Amended Section 75W to Stage 1 Mixed Use Development (MP10_0030)

Discovery Point, Wolli Creek

Submitted to Department of Planning and Infrastructure
On Behalf of Discovery Point Pty Ltd and Discovery Point Devt Pty Ltd

November 2012 ■ 12505

Figure 2 – Southern Precinct Site Plan

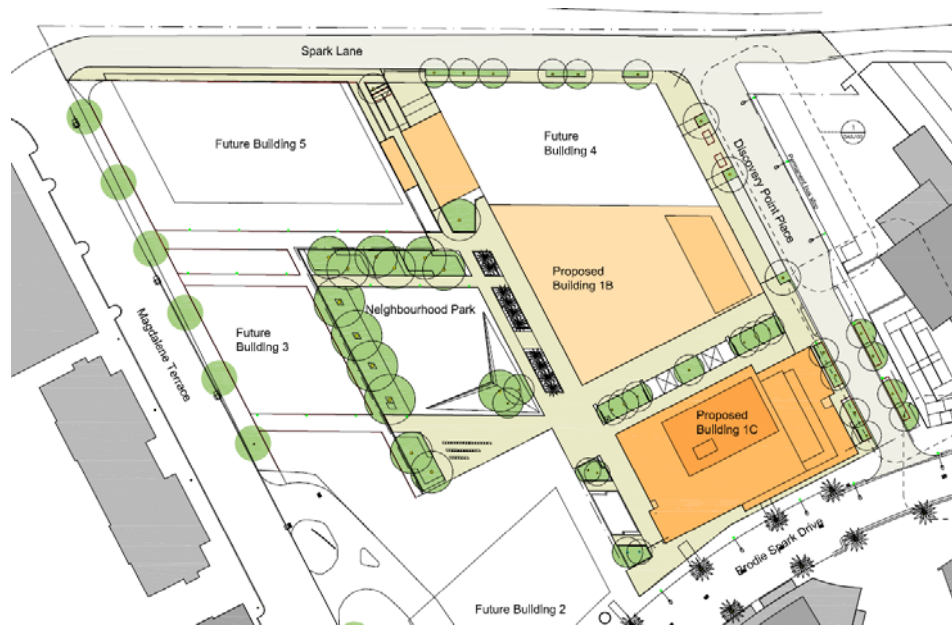
Due to practicalities in delivering the construction programme and associated site facilities for Stage 1 and Stage 2, the temporary park (turfed area) is no longer proposed to be established along Magdalene Terrace on future building Sites 3 and 5 (refer to **Figure 2**). This is due to the fact that current construction programming would require the demolition and hoarding of the temporary park prior to the Practical Completion of it. This is nonsensical and due to its proximity to Stage 2 would be a safety issue if left as a grassed park area whilst Stage 2 is being constructed. Further, Stage 2 is a tall building and requires most of Stage 3 site area for site establishment and crane base as well as material laydown. Australand will ensure travel paths to the Station from Magdalene Terrace are provided however this will need to be co-ordinated with construction staging to ensure safety of pedestrians.

Figure 3 – Proposed revised Spark Lane (west) elevation

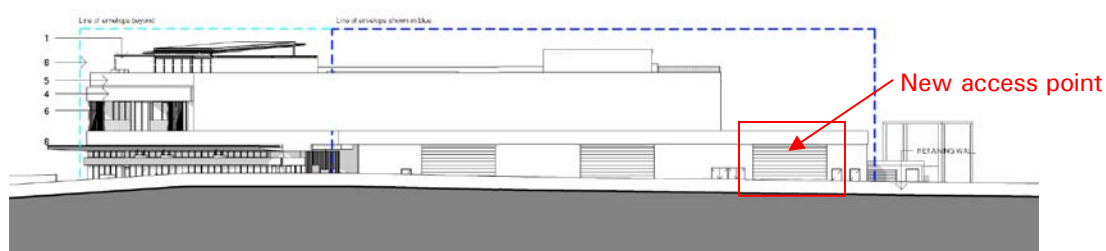
The rear of Building 1B fronting Spark Lane was approved as providing non-active ground floor uses (loading dock, residential waste room, services etc) consistent with the Development Design Guidelines (clause 9.3.1). This approach to the rear of Building 1B will remain, with the introduction of an additional/third vehicle access point along the ground floor elevation and the removal of the waste room access door.

Overall, the proposed introduction of an additional vehicle access point along the rear ground floor elevation ground of Building 1B will have no material impact on the building's appearance (in context with the existing service lane character – refer to **Figure 3**).
